STATE LEVEL EXPERT APPRAISAL COMMITTEE (SEAC)-DELHI
OFFICE OF DELHI POLLUTION CONTROL COMMITTEE
5th FLOOR, ISBT BUILDING, KASHMERE GATE, DELHI-110006

Minutes of the 106th Meeting of State Level Expert Appraisal Committee (SEAC) held on 18.06.2022 at 11:00 AM in the Conference Room of DPCC, at 5th Floor, ISBT Building, Kashmere Gate, Delhi 110006.

Name of the Project	TOR for Development of DTC Colony at Hari Nagar, New Delhi
Project Proponent	General Manager, M/s NBCC (India) Limited, Ground Floor (Tower No. 4), Office Block, East Kidwai Nagar, New Delhi, 110023
Consultant	IND TECH HOUSE CONSULT
Project EIA coordinator present during the meeting	EIA Coordinator (Soumya Dwivedi Partner (Intech House) Anand Kumar Dubey FAE-AP.WP(Indra Kumar Sharma
Rep. Of the PP present during the meeting	G.M(Bibhash Kumar) Sr. Manager (Civil) Rishi RAjpipil Architect (Surendra Bisht)
Proposal No.	SIA/DL/MIS/77279/2022
File No.	DPCC/SEIAA-IV/C-399(TOR)/DL/2022

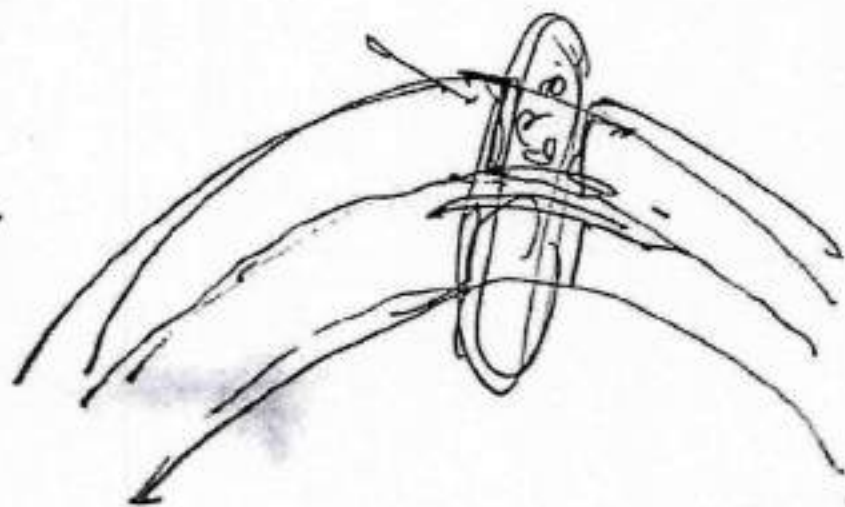
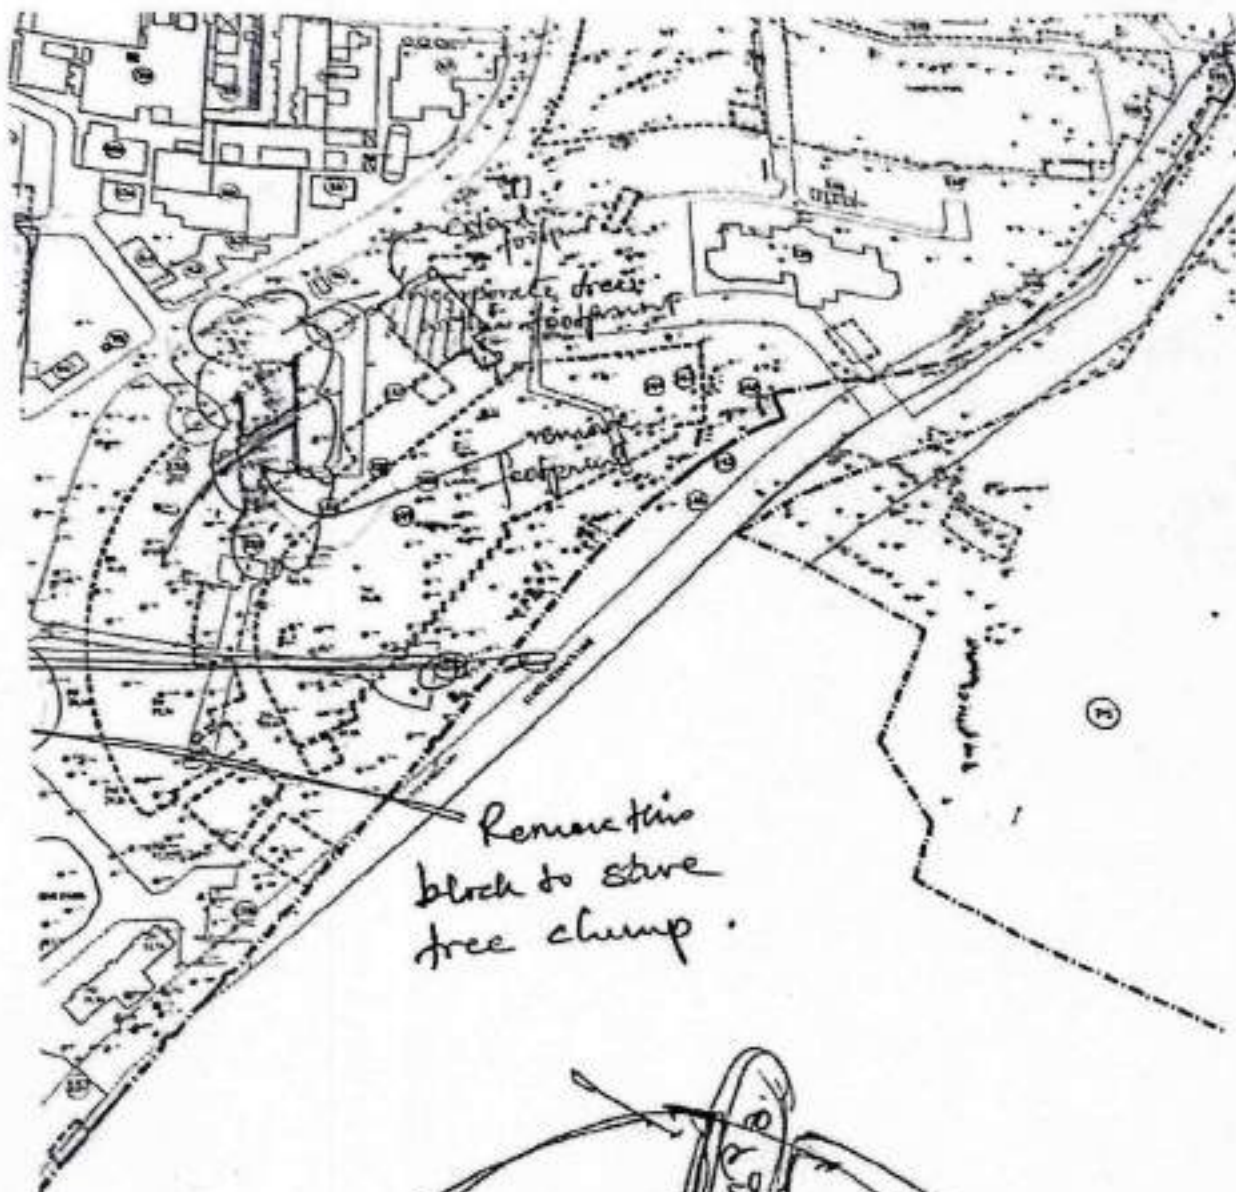
Based on the site visit and interaction, and review of documents, the following clarifications and improvements need to be provided by the project proponent:

1. Additional measures for preservation of natural ecology and existing full grown wide-girth trees should be demonstrated through the following:

- a. Map showing topography & slope analysis of site and natural storm water management strategies
 - b. Existing full grown wide girth trees - 3 separate maps need to be provided. :

- i. Map showing outlines of proposed building blocks and showing in different colours the Trees being cut, transplanted & preserved;
 - ii. Map showing outlines of proposed building blocks and showing the variations in Tree Girths in different colours (< 6 inch, 6 inch - 1 ft, >1 ft);

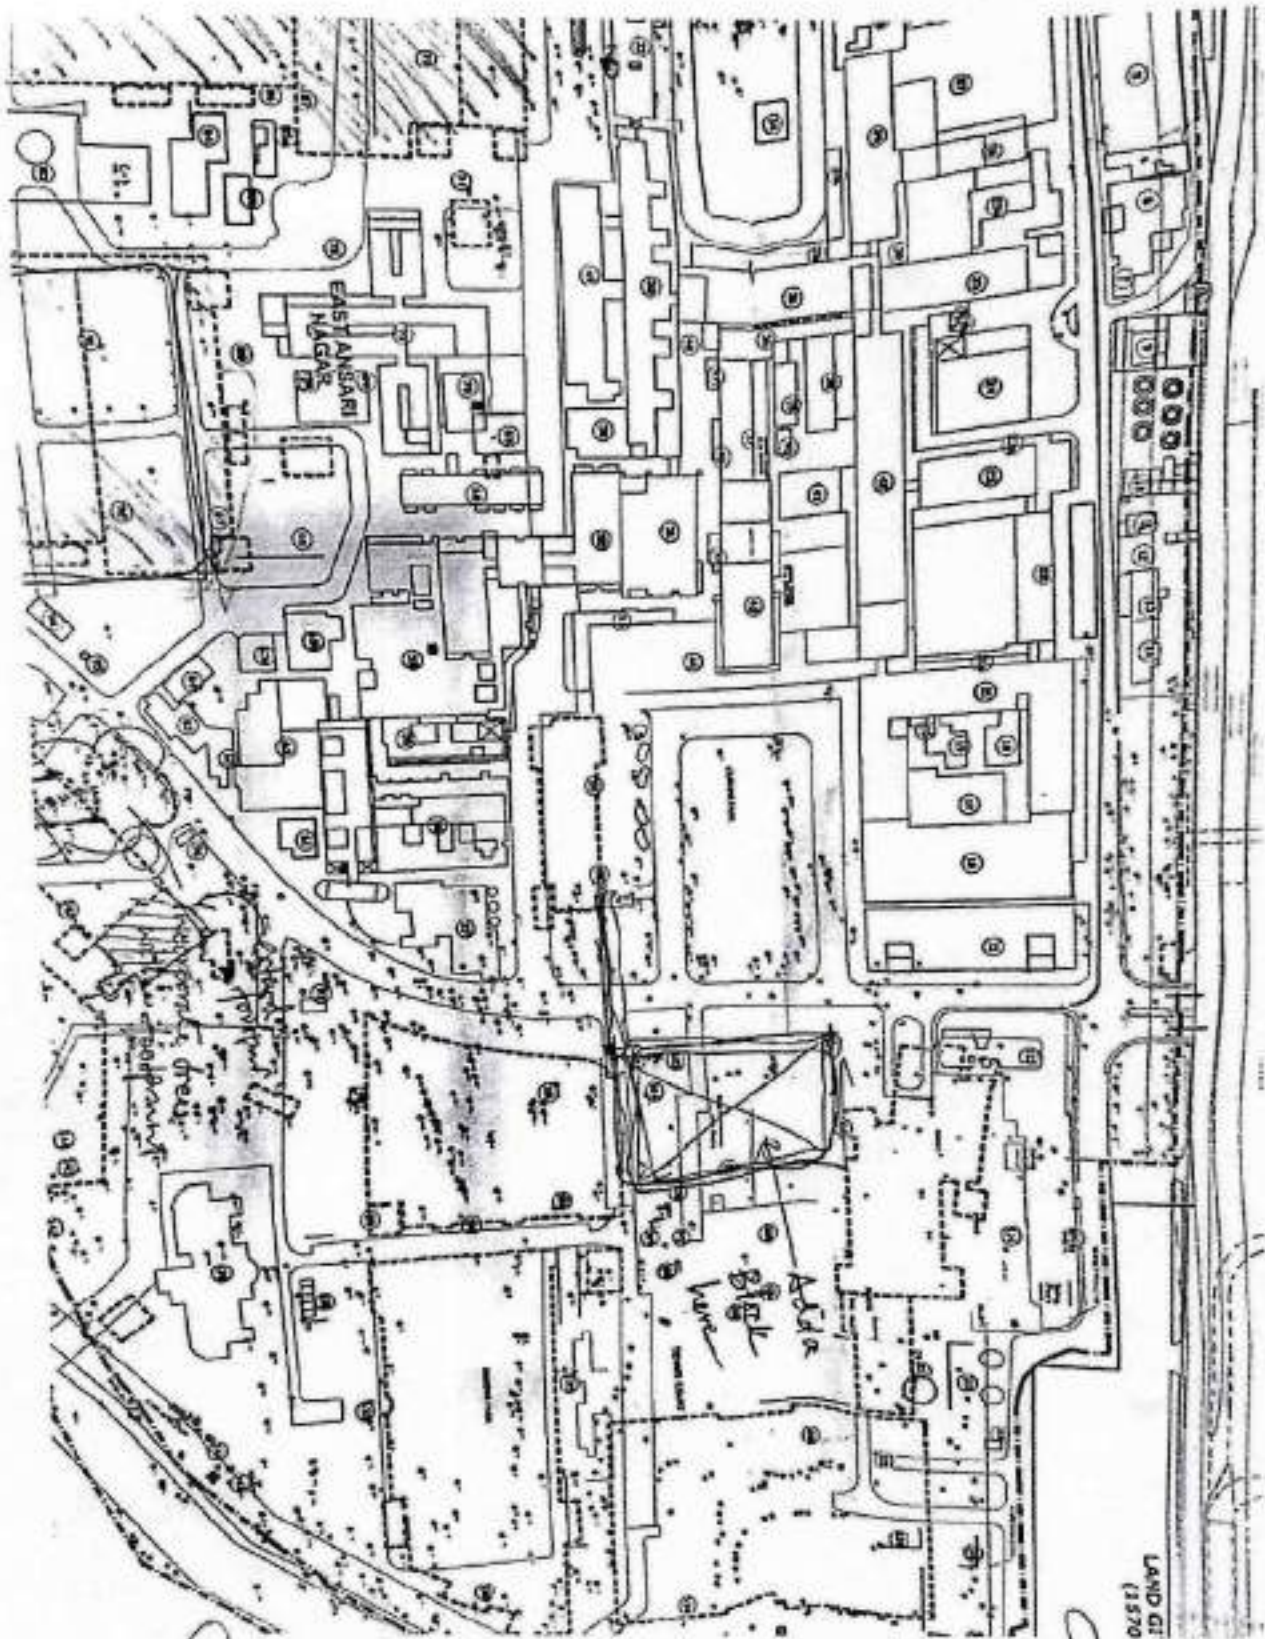
4. Clarifications/ necessary modifications regarding Energy & Sustainable Building Design be provided with -

1. The lighting and ventilation methodology of larger footprint podium/ basement areas needs to be justified.
2. Emergency exit plans
3. Daylighting plan for all habitable spaces
4. Building design strategies to preserve more trees within the proposed footprints. (Refer sketches enclosed).
